**Town of Kittery
Planning Board Meeting
January 26, 2023**

ITEM 1 – 22 Shapleigh Road– Site Plan - Preliminary Plan Review

Action: Determine application completeness, schedule site walk, schedule public hearing. Owner/applicant Fair Tide and acting agent Geoffrey R Aleva, PE of Civil Consultants propose to redevelop an existing commercial building with additions creating a footprint of 5,669sf, and to add a 6-unit residential building consisting of a 2,058sf building footprint, at real property located at 22 Shapleigh Road (Tax Map 15, Lot 64) in the Business-Local (B-LI) and Residential-Urban (R-U) Zones respectively.

**PRE-DEVELOPMENT
 STORMWATER
 MANAGEMENT PLAN**

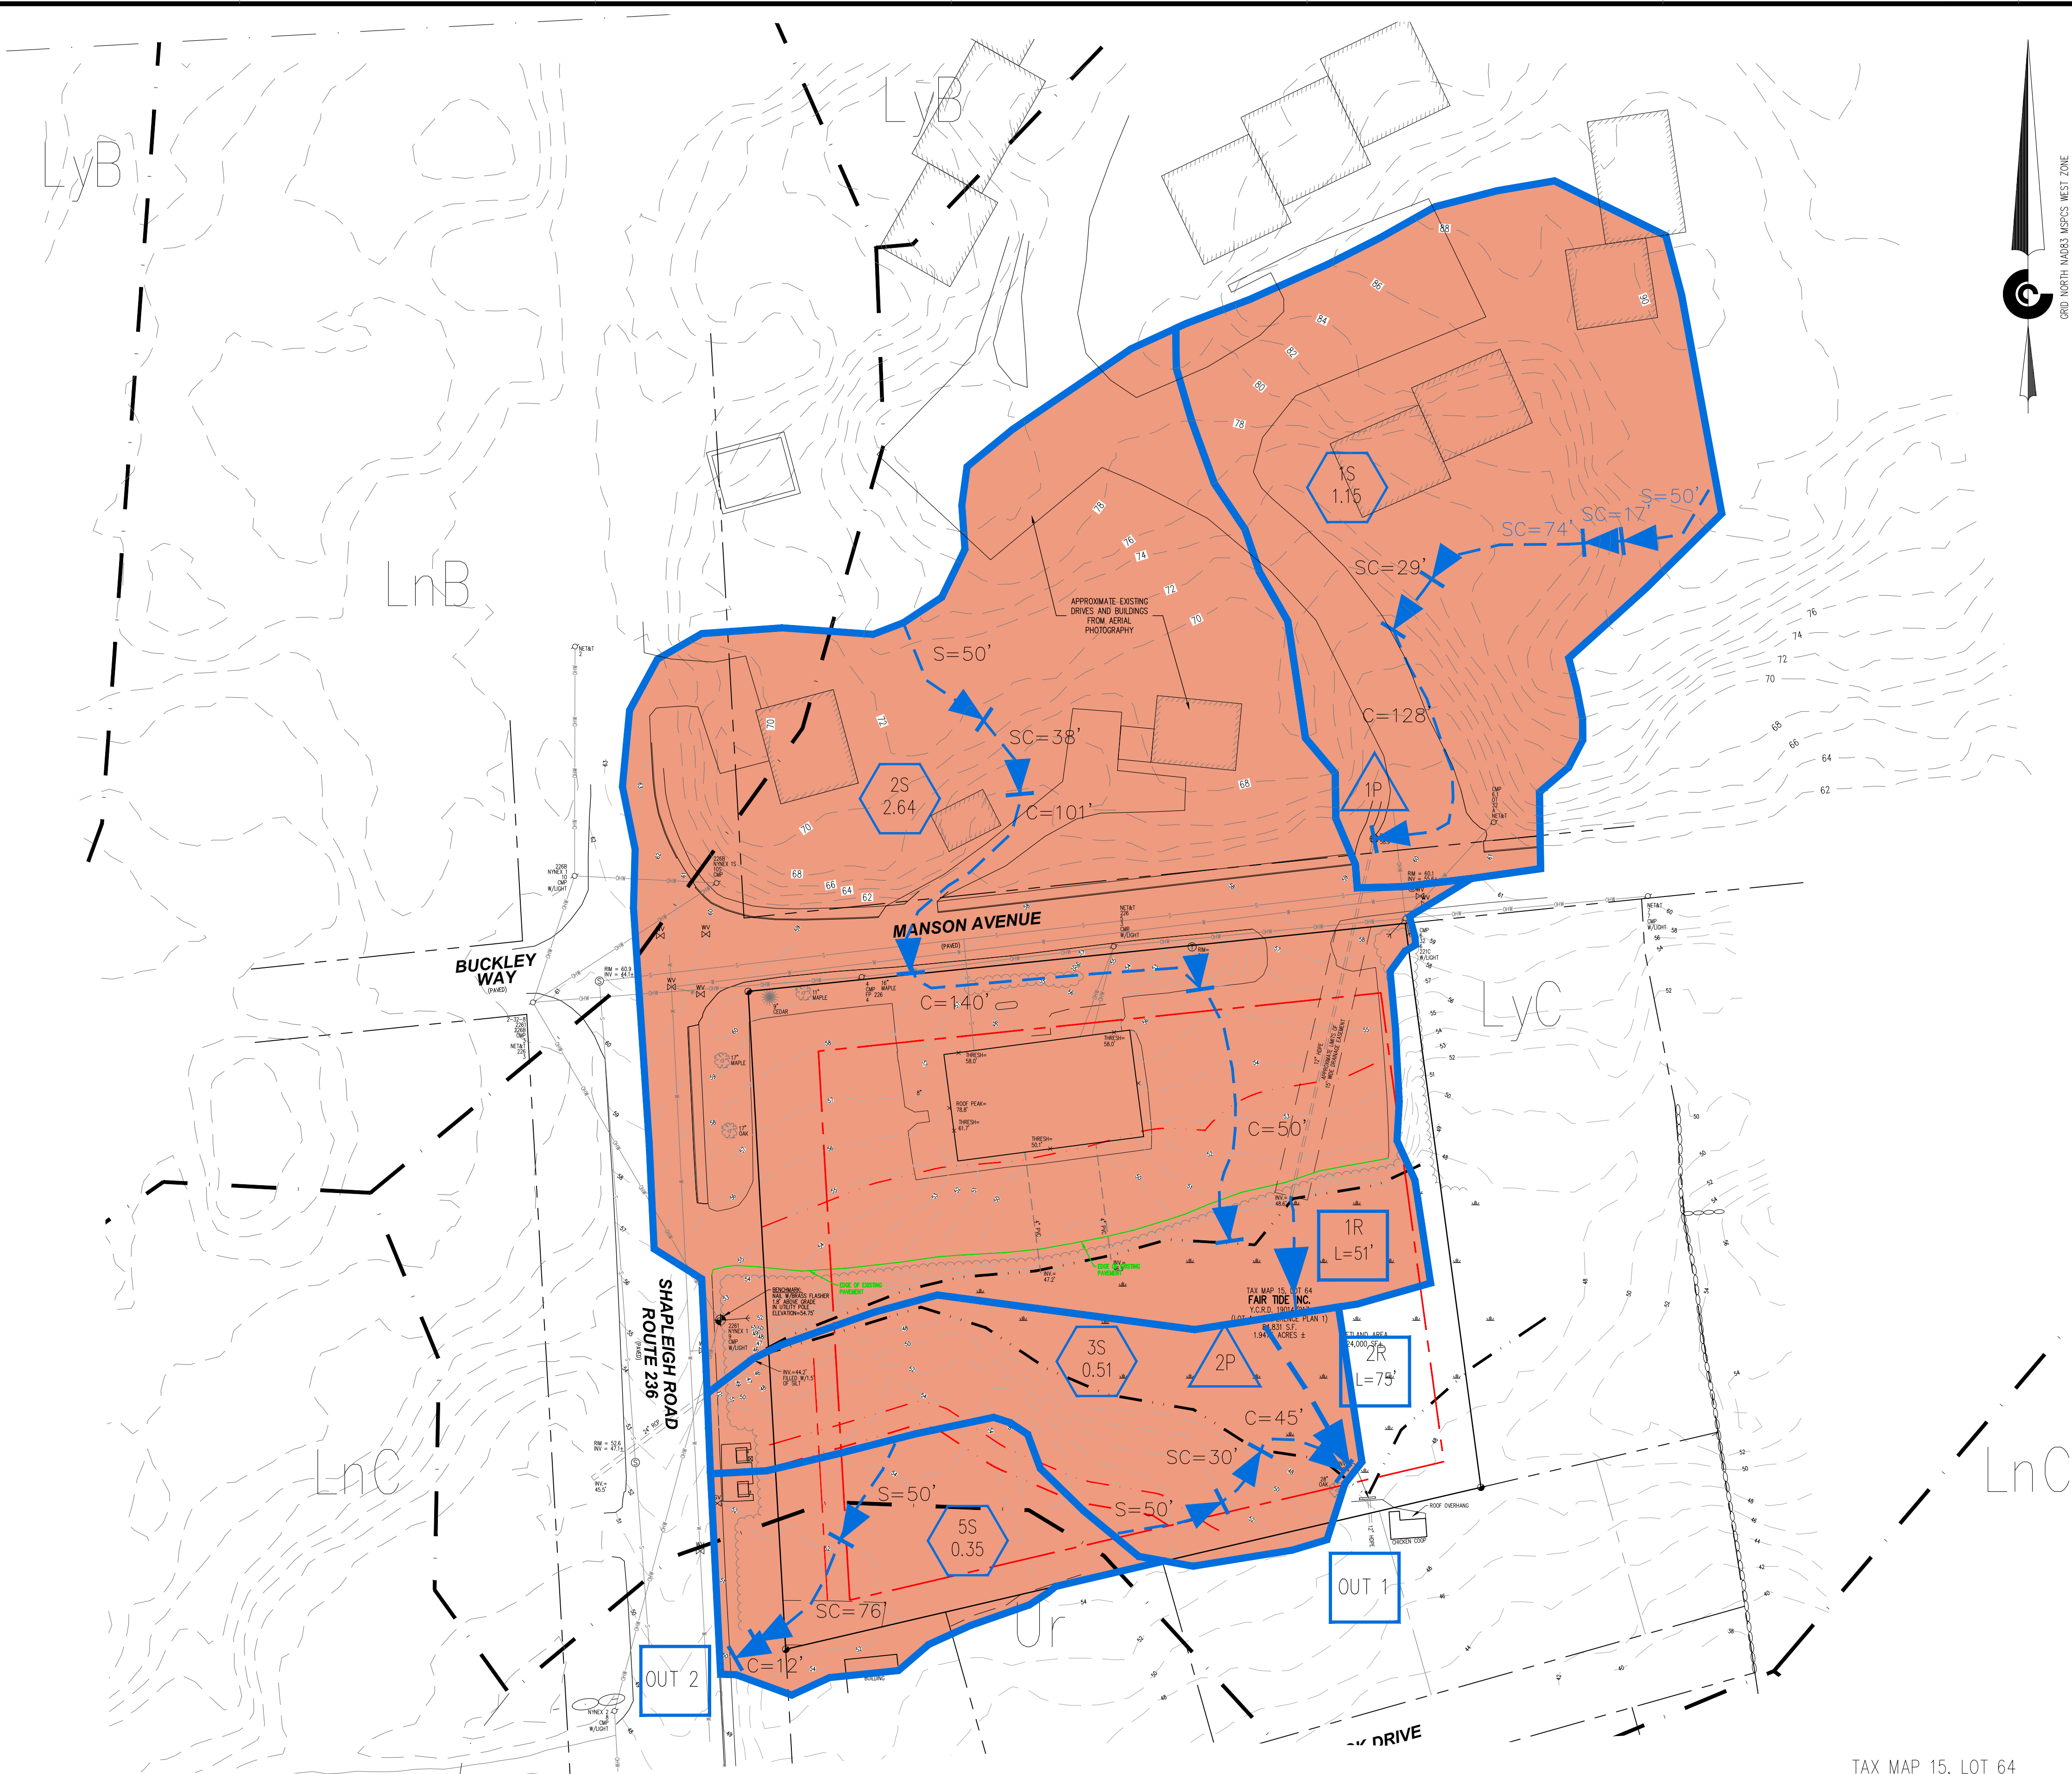
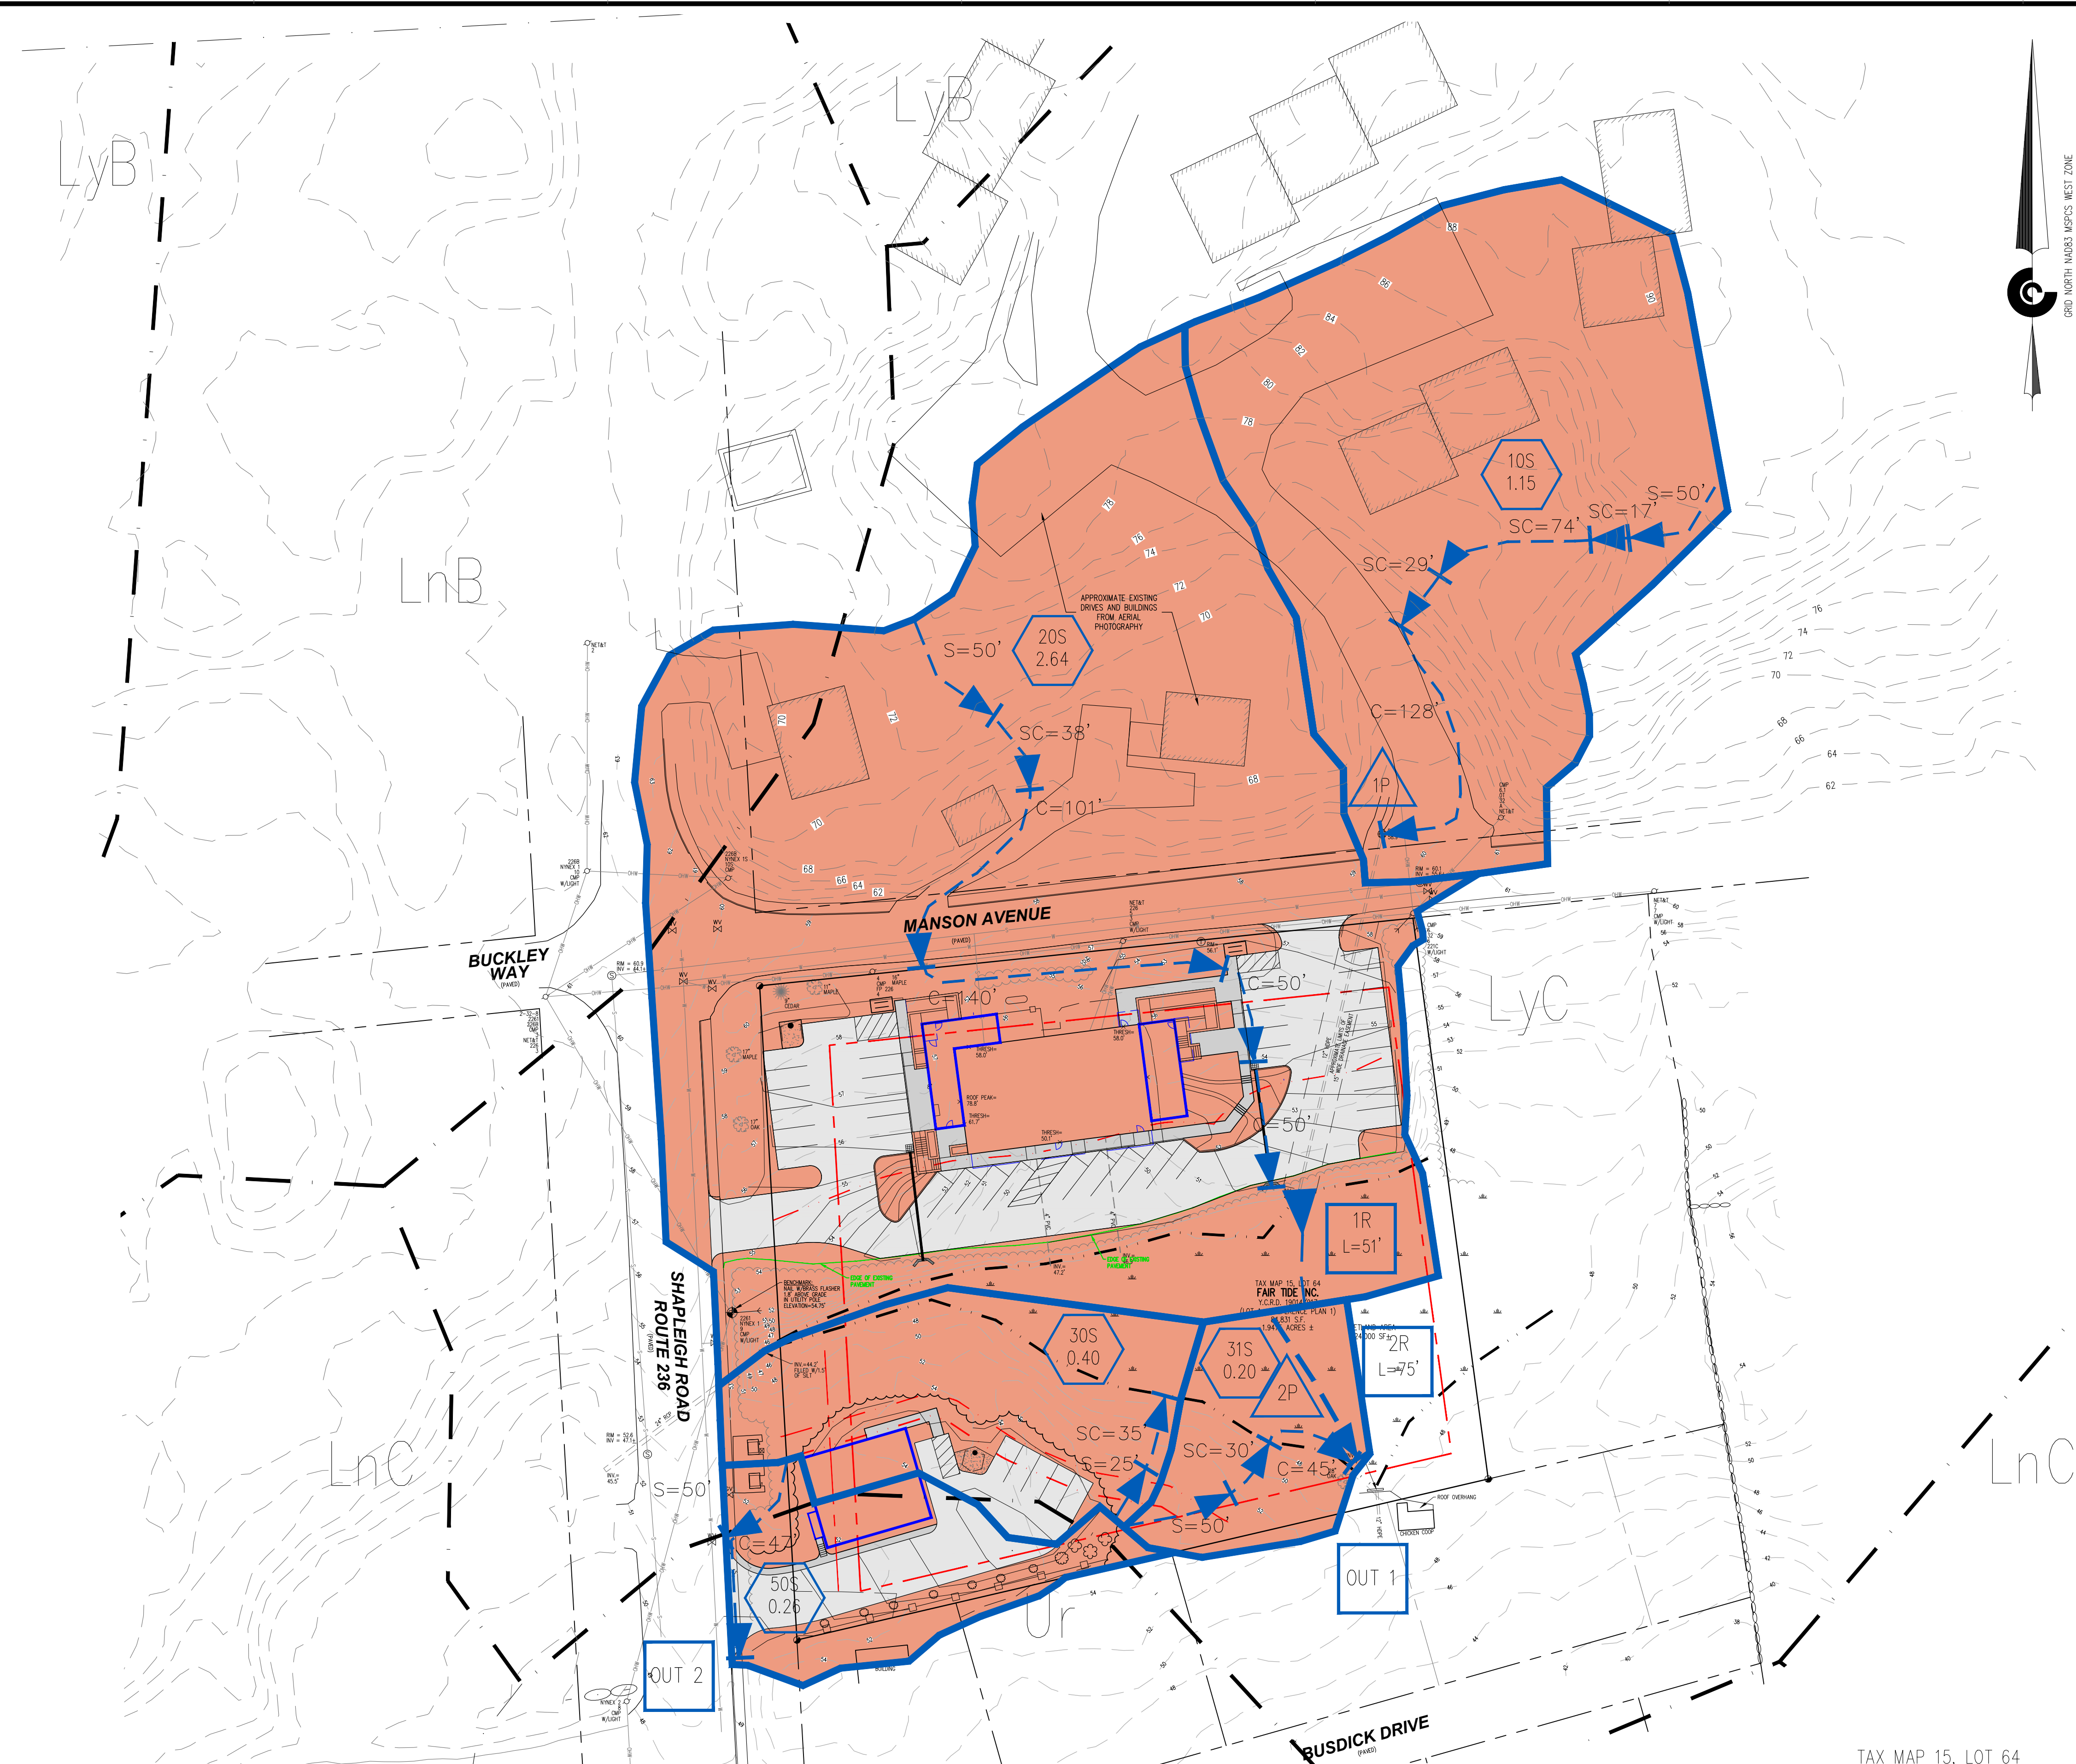
- 85 *property rights for off-site drainage? (“Out 1” on drainage plans). Should the board request peer*
- 86 *review for verification that off-site runoff will match pre-development conditions and Town*

- 87 *requirements, including LID and BMP measures?*
- 88 • a.4.j: **hours of operation and hours of exterior lighting** are required to be limited. Final plans
